**From:** Bonnie Chiu  
**To:** [Moore-Love, Karla](#)  
**Cc:** [Reynolds, Allison J. \(Perkins Coie\)](#); [Tim Wybenga](#)  
**Subject:** Fremont Apartments Appeal -- LU 16-278621 DZM GW -- Additional Record Materials  
**Date:** Wednesday, April 18, 2018 3:59:32 PM  
**Attachments:** [2018-04-18 Fremont Apartments - Addl Information re Design Revisions.pdf](#)

Re: Fremont Apartments Revised Design  
Appeal of DR Approval LU 16-278621 DZM GW

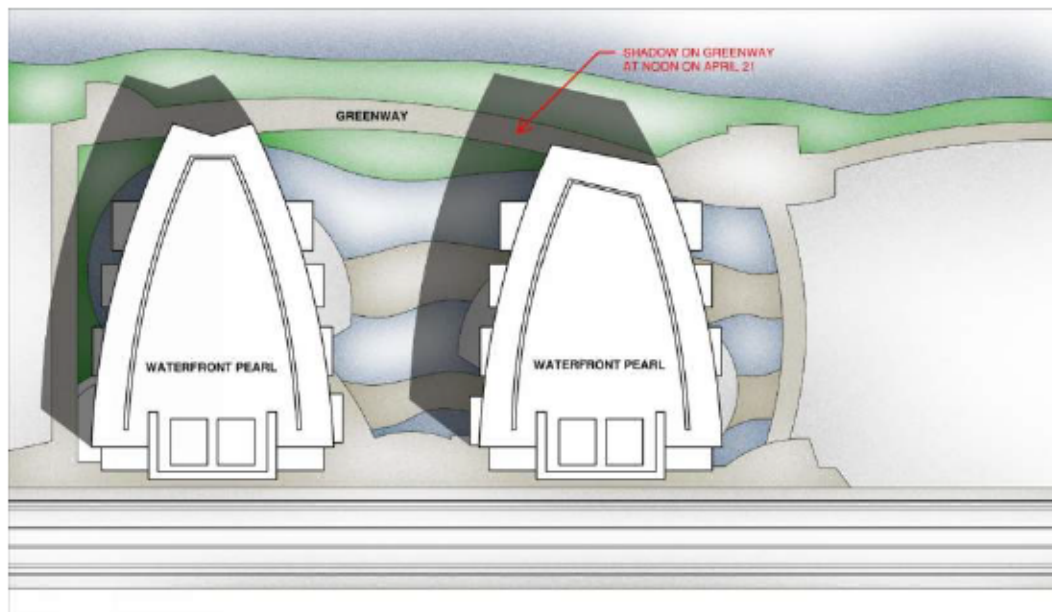
We heard that the building was too close to the 25-foot Greenway setback. Along these lines, there were concerns that the building would stick out as a sort of “buck-tooth” after redevelopment of other neighboring properties, which Council assumed would be under a 50 foot Greenway setback contemplated under the CC2035 plan. Additionally, a Council member raised concerns about the success of the planned restaurant space with an outdoor seating area in close proximity to the Greenway trail.

To address these concerns, we widened the distance between the seawall and the building’s edge to between 43 feet 4 inches and 47 feet 9 inches, a substantial increase over the previous design. This setback distance approximates the 50-foot Greenway setback under CC2035. As Council is no doubt aware, the draft CC2035 plan would allow buildings to encroach up to 5 feet into the 50-foot setback line, as long as an equal amount of area was reserved on site behind the 50-foot setback line. The Revised Design approximates a building that would be allowed under those restrictions and would not stick out like a buck-tooth adjacent to properties developed under those rules.

The increase in space between the seawall and the building façade allows for a wider Greenway trail path (as discussed below), and for more space between the path and the building. An average of 12 feet of hardscape, landscaping and seating areas now separate the edge of the restaurant deck from the Greenway path.

Fremont Apartments shadow on Greenway –  
PREVIOUS approved design

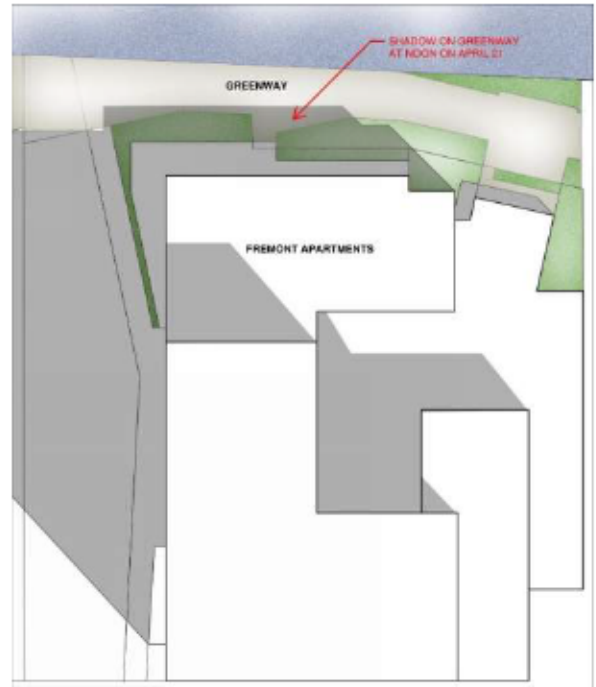
A Council member raised questions about the amount of shade cast on the Greenway area by the building. There is not a Code standard (under the applicable Code or CC2035) that restricts building mass and orientation based on shadows cast on the Greenway. Most development adjacent to the Greenway casts shadows on the area at different times of the day and year. Below we have provided a depiction of the shadows cast by our approved design, Revised Design, and, for context, the Waterfront Pearl. The shadows shown here are at noon on April 21. Although there is not a shadow standard for the Greenway, we use this date and time for consistency with the shadow requirements for the plaza area.

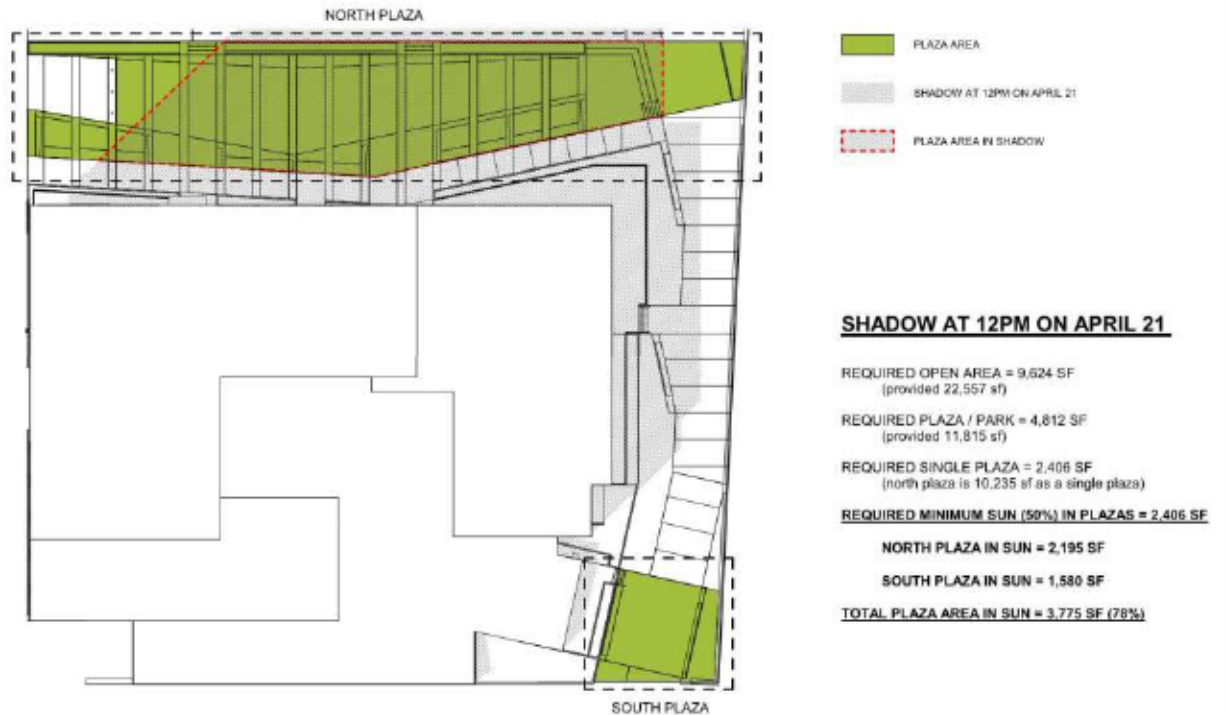
*Allow North Plaza to Be More than 50% Shaded on April 21 at Noon*

- **Change:** We are adding a second plaza space at the south end of the building which will be full in sun (0% in shadow) on April 21 at noon. We are working with Staff to determine if a modification is still required for the north plaza.
- **Explanation:** The Revised Design provides a second 1,580 SF plaza at the building's south end that is 0% in the shade April 21 at noon. This plaza meets the shadow standard.
